TECHNICAL MEMORANDUM

TO: Dr. Robert Leidy, U.S. Environmental Protection Agency (EPA) Region 9

FROM: Dr. Mathias Kondolf, consulting fluvial geomorphologist, Berkeley, California, and James Ashby, PG Environmental, LLC, Golden, Colorado

SUBJECT: Conceptual Design for Sonoita Creek, AZ, Technical Review Support (Order Number EP-G149-00241)

Figure 2a. Hydrologic soil group map and color-coded ratings for Sonoita Creek area (see next page for map legend).

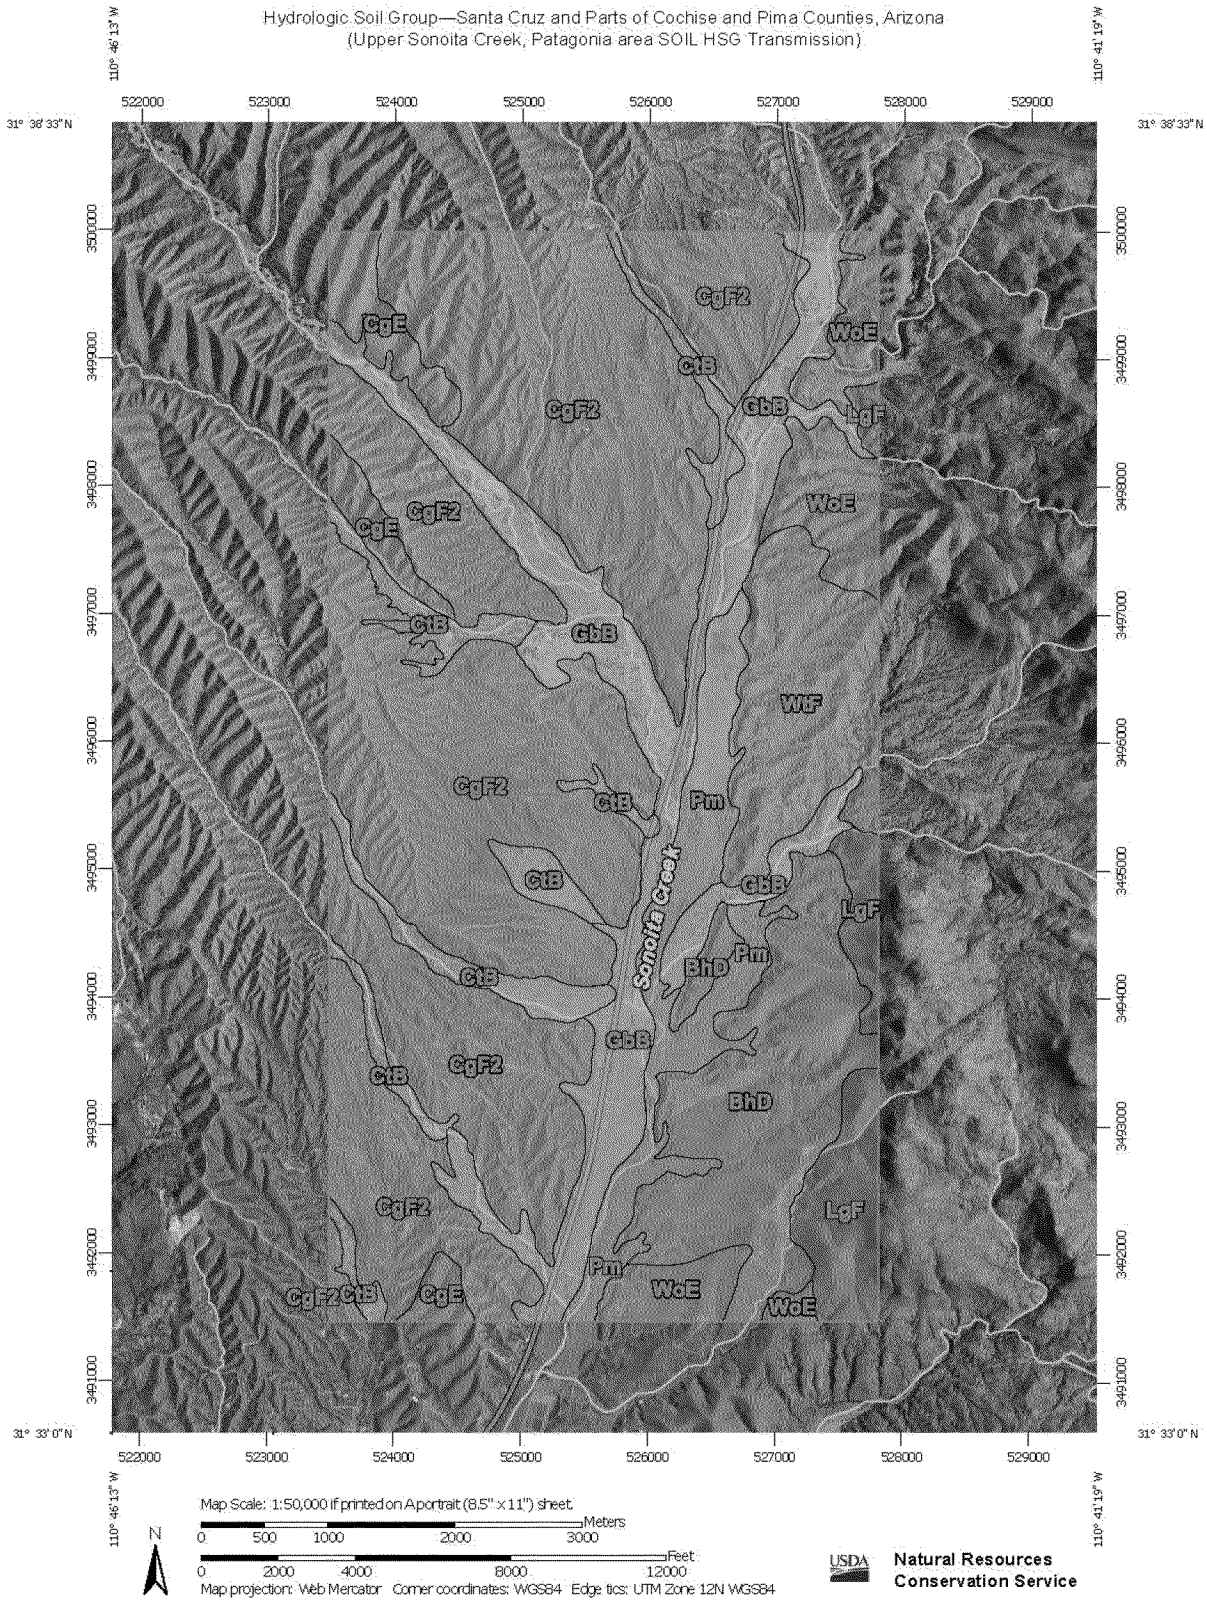
3) **The proposed constructed channels will likely not sustain flow in the specific soil types within the project reach.** The Sonoita Creek valley bottom consists primarily of alluvial deposits. In terms of mapped soil units, it is dominated by Grabe-Comoro complex (GbB) soils of gravelly sandy loam to sandy loam composition, that receive a hydrologic soil group classification (HSG) of Group A (refer to Figure 2a and 2b). Group A soils are characterized by high infiltration rates, low runoff potential, and a high rate of water transmission. The Sonoita Creek floodplain also has a lesser percentage of Pima soils (Pm), a clay loam that receives a HSG classification of Group C. Group C soils are characterized by slow infiltration rates and slow water transmission.

Transmission losses due to infiltration into the bed and banks are high in semiarid ephemeral streams, and multiple researchers have demonstrated that except during the highest flows, there is significant loss of in-stream flow due to seepage as the flow proceeds downstream in alluvial valleys (Levick, et al. 2008). The WET report (p.12) notes that transmission losses for streams like Sonoita Creek have been reported as high as 17-29%. Approximately half of the constructed pilot channels as proposed in the plan would be excavated into the highly permeable Grabe-Comoro complex soils, resulting in high transmission losses. Any portion of the flow that entered the newly constructed channels during low to moderate flow rate events, such as those that occur at a high frequency annual scale, would likely not be sustained, and likely not return to the main Sonoita Creek channel. Sediment drops out of suspension as infiltration occurs and flow drops in velocity, depositing new material in the channel. Resulting aggradation may fill the newly constructed channels, further restricting the ability of flows to be diverted and for any diverted flow to successfully return to the main Sonoita Creek channel, particularly at the downstream reaches of constructed channels. Continued aggradation in the constructed channel could eventually create an abandoned, non-functional channel. The overall result would be a loss of habitat in the main channel of Sonoita Creek and a failure to create new habitat in the constructed channels, therefore failing to meet the stated goals of the proposed design in the WET report.
